BRIDGEPORT WEST SEWER IMPROVEMENTS
SECTION C – LIFT STATION IMPROVEMENTS
CITY OF SIOUX CITY, IOWA
Project No. 6827C-539-201 – 2016

ADDENDUM NO. 3

March 4, 2016

SHEET NO.
C.01

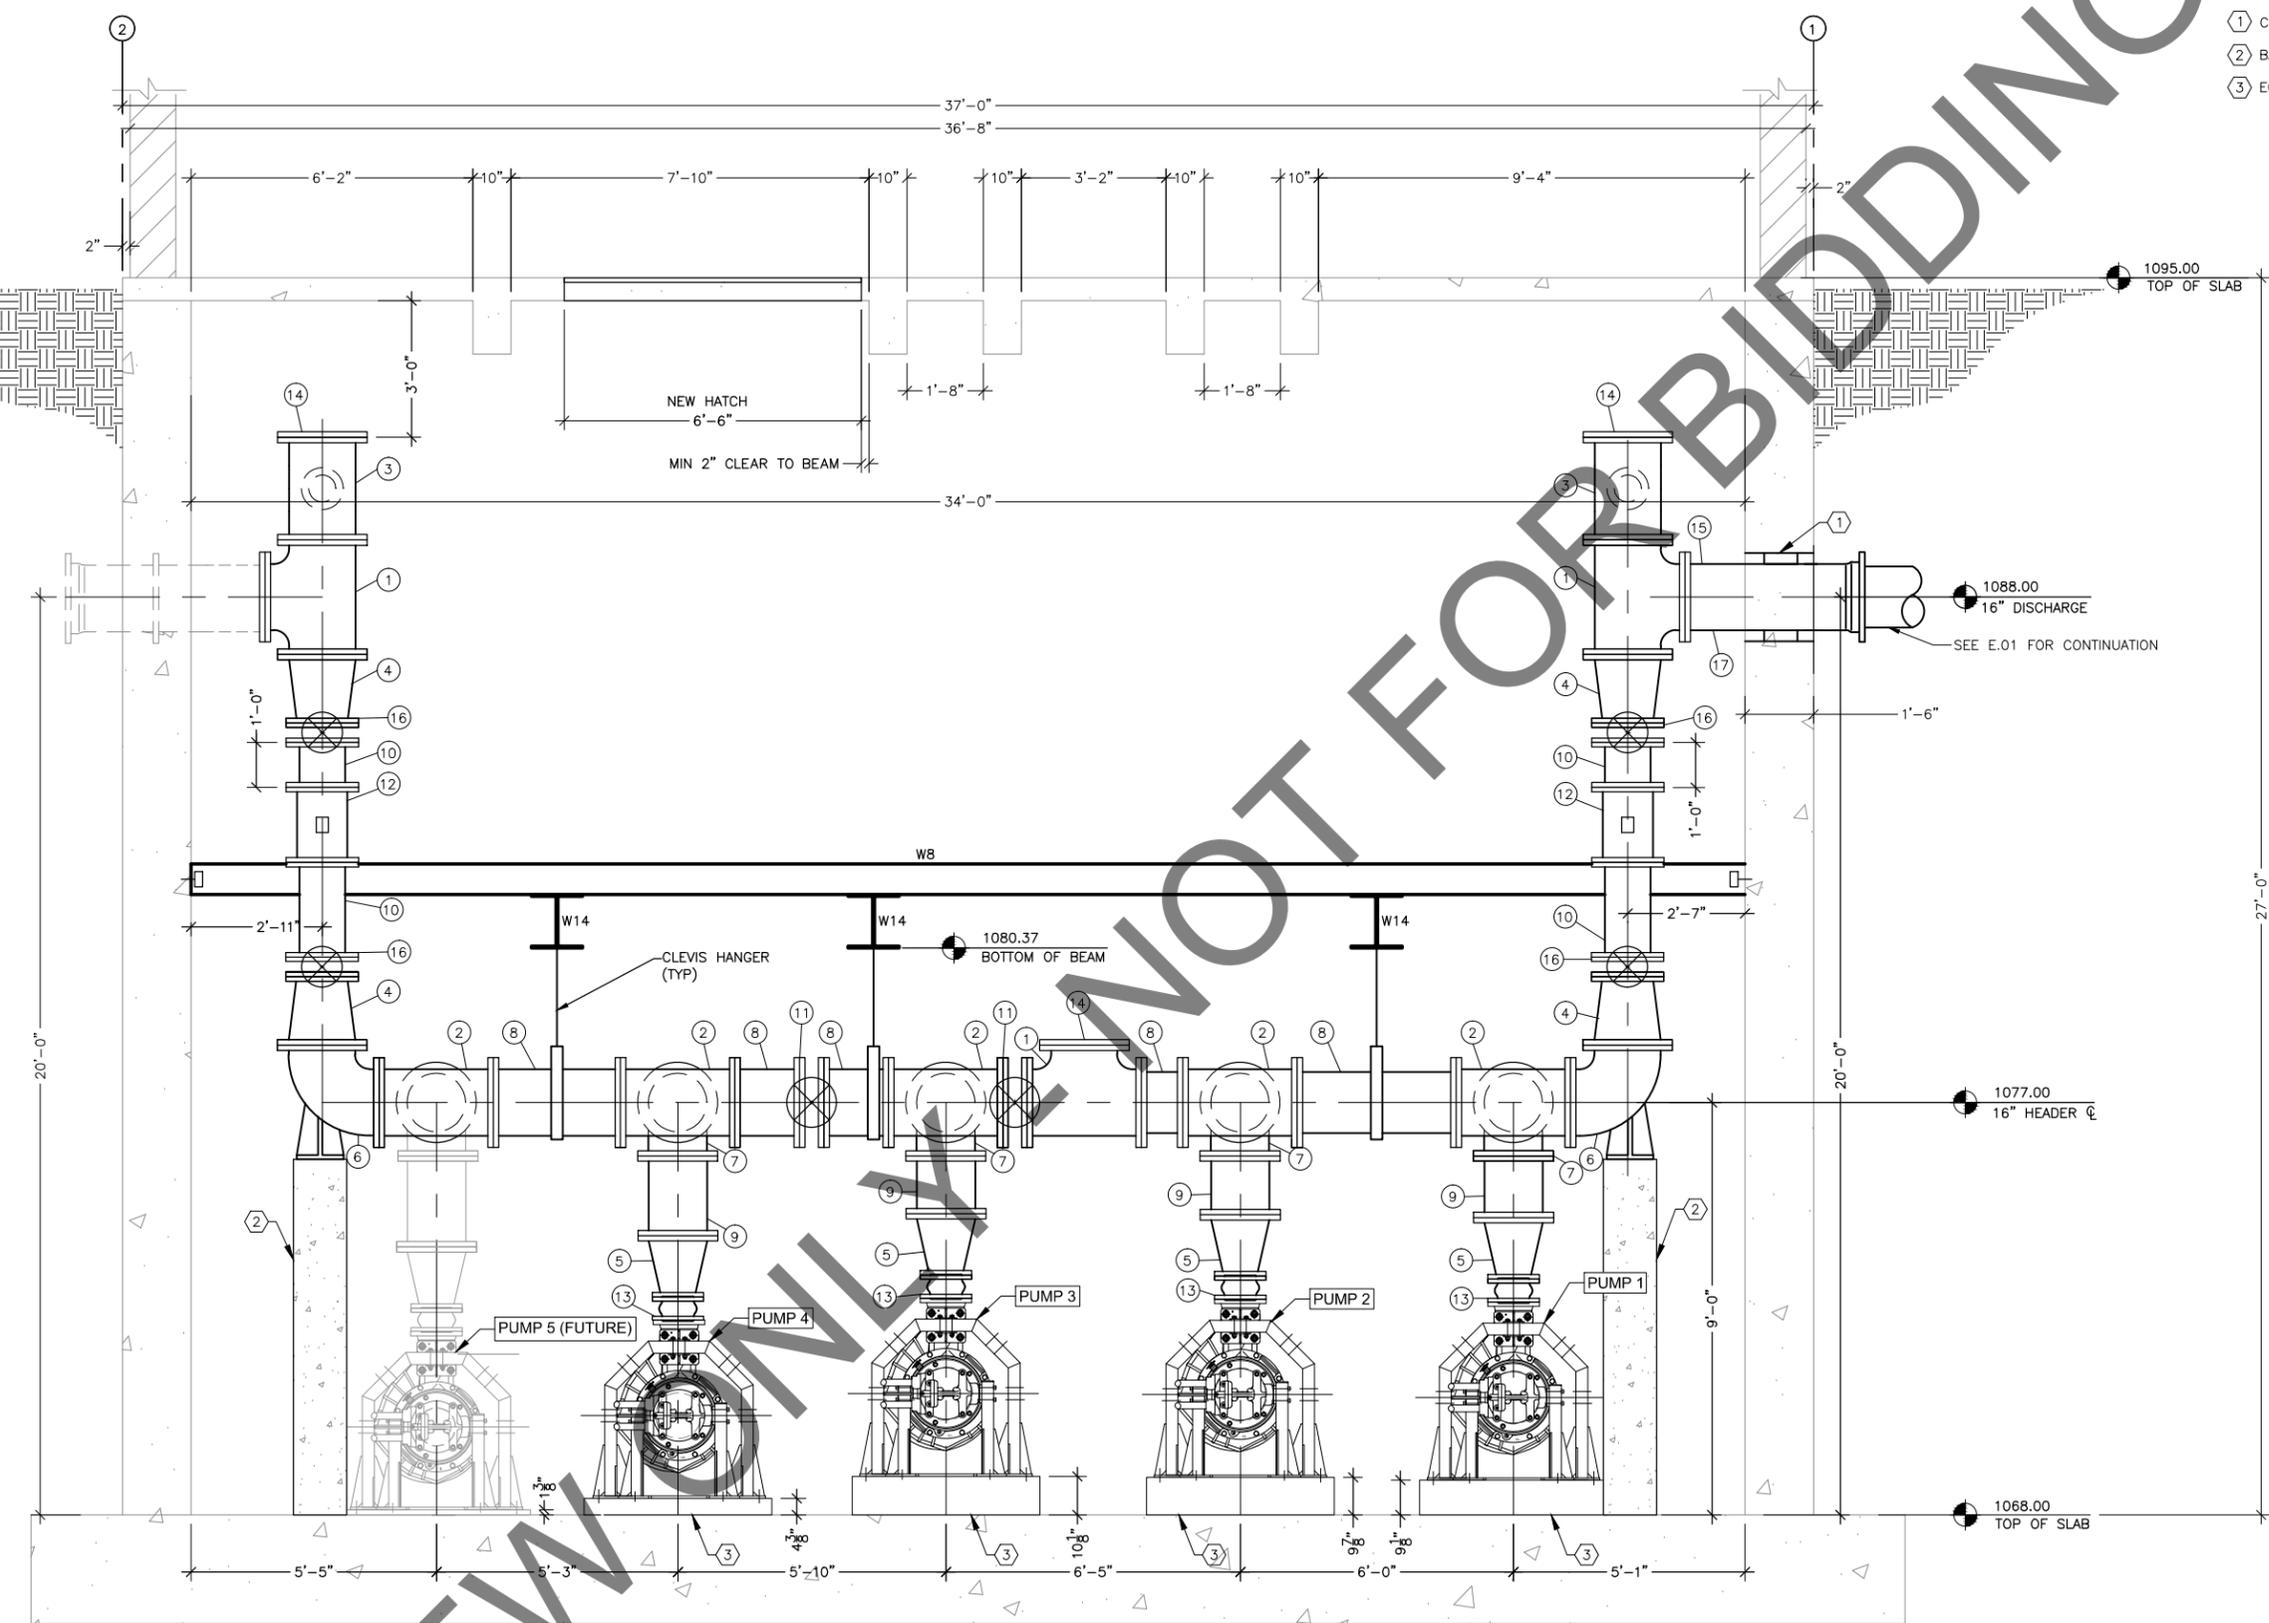
NO.	DATE	BY	REVISION DESCRIPTION
2	3/2/16	JV	ADD BID ITEMS, REVISE QUANTITIES
3	3/4/16	JV	REVISE QUANTITY OF ITEM 22 AND ITEM 54

SHEET NO.
E.11

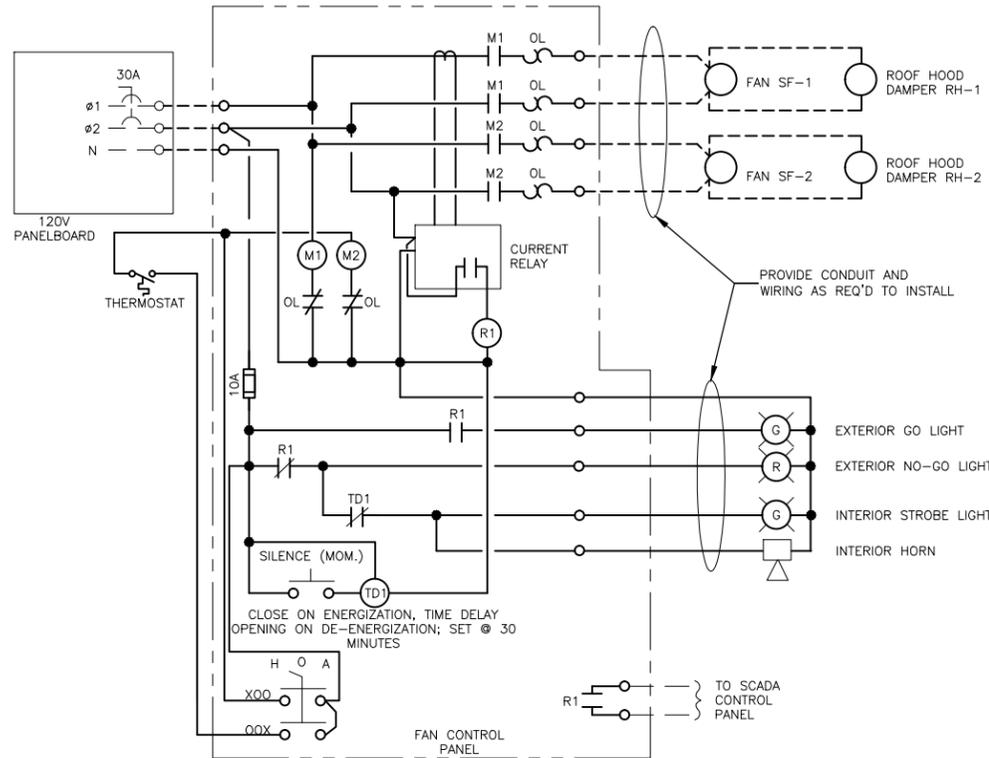
NO.	DATE	BY	REVISION DESCRIPTION
2	3/2/16	JV	ADD TEMPORARY BYPASS SHEET
3	3/4/16	JV	REVISE & ADD BYPASS ROUTE, ADD NOTES

- 42" BYPASSING NOTES:**
1. PLUG EXISTING 36" LINE DURING WORK IN LIFT STATION, AND BYPASS FLOW VIA CONSTRUCTED BYPASS CONNECTION.
 2. CONTRACTOR TO PROTECT MANHOLE OPENING DURING DURATION OF BYPASS PUMPING.
- AVERAGE FLOW: 1.20 MGD, 50.0 TDH
 - PEAK FLOW: 2.88 MGD, 64.0 TDH
3. GELITA DISCHARGE ELEVATION: 1100.8±
 4. GELITA PIPE LENGTH FROM NEW FORCE MAIN CONNECTION TO DISCHARGE: 4,400.

- KEY NOTES:**
- 1 BYPASS ROUTE
 - 2 PRIOR TO BEGINNING WORK ON YORK LIFT STATION, INSTALL CLEAN OUT. CAP WYE TO LIFT STATION TO USE FORCE MAIN CLEAN OUT FOR BYPASSING. SUPPLY NECESSARY FITTING FOR COMBINED USE OF BOTH BYPASS LINES
 - 3 ROUTE BYPASS LINE INSIDE 18" STORM CULVERT.
 - 4 BYPASS FLOW OUT OF MANHOLE.
 - MANHOLE DEPTH: 22.9'
 - MANHOLE INVERT ELEVATION: 1074.7±
 - MANHOLE Ø: 60" WITH 48" CONE.
 - HIGH WATER ELEVATION: 1076.2±
 - 5 BYPASS FLOW OUT OF MANHOLE IN COORDINATION WITH CIPP LINING OF THE 36" LIFT STATION INFLUENT LINE BY OTHERS.
 - MANHOLE DEPTH: 15.3'
 - MANHOLE INVERT ELEVATION: 1079.1±
 - HIGH WATER ELEVATION: 1081.7±

- GENERAL NOTES:**
1. MAINTAIN WORK WITHIN CITY PROPERTY OR RIGHT OF WAY.
 2. MONITOR UPSTREAM MANHOLE DURING BYPASSING TO ENSURE THAT PIPE DOES NOT BECOME FULLY SURCHARGED.
 3. LINE DR CAN ONLY BE CLOSED FOR ONE WEEK AND IT CANNOT BE CLOSED AFTER MAY 11TH, 2016.
 4. SEE J SHEETS FOR TRAFFIC CONTROL.
 5. COORDINATE WITH OWNER. BYPASS ESTIMATED TO START IN LATE AUGUST, 2016.

SHEET NO.
J.01

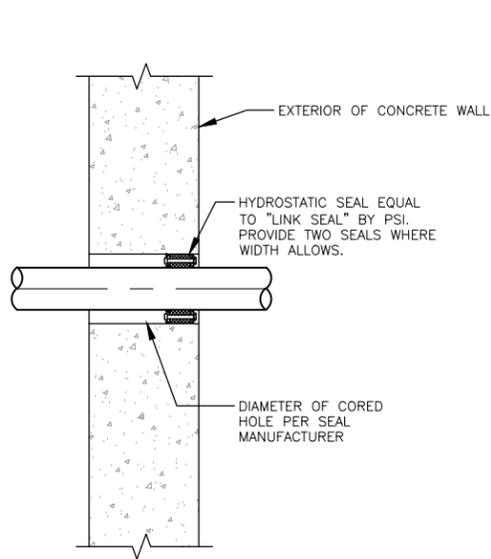
NO.	DATE	BY	REVISION DESCRIPTION
2	3/2/16	JV	CHANGE DETOUR ROUTE TO STADIUM DR, NOTE 1
3	3/4/16	JV	CHANGE ROAD CLOSURE TYPE, ADD KEY NOTE 1

- 1 SOUTHGATE DRIVE TRAFFIC CONTROL SHALL BE IMPLEMENTED IN COORDINATION WITH YORK LIFT STATION SHUTDOWN AND BYPASS PUMPING. ESTIMATED TIME OF SHUTDOWN IS 10 WEEKS. SEE SHEET E.11.

7 YORK/GELITA CONNECTION

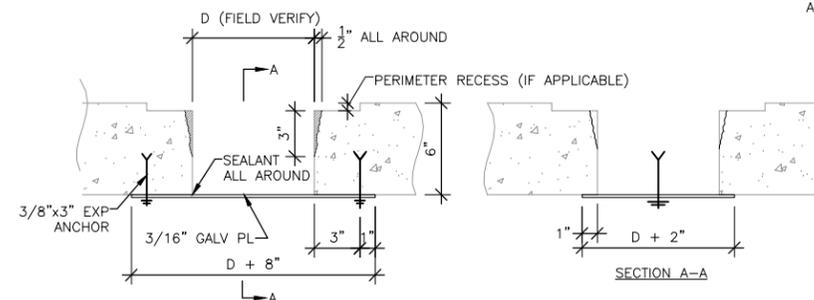
NO.	DATE	BY	REVISION DESCRIPTION
2	3/2/2016	JV	ADD SLEEVE TO DETAIL 7
3	3/4/2016	JV	ADD NOTE TO DETAIL 7

3 CONTRACTOR TO FIELD VERIFY 20" C905 PVC PIPE CLASS PRIOR TO MAKING FORCE MAIN CONNECTION.
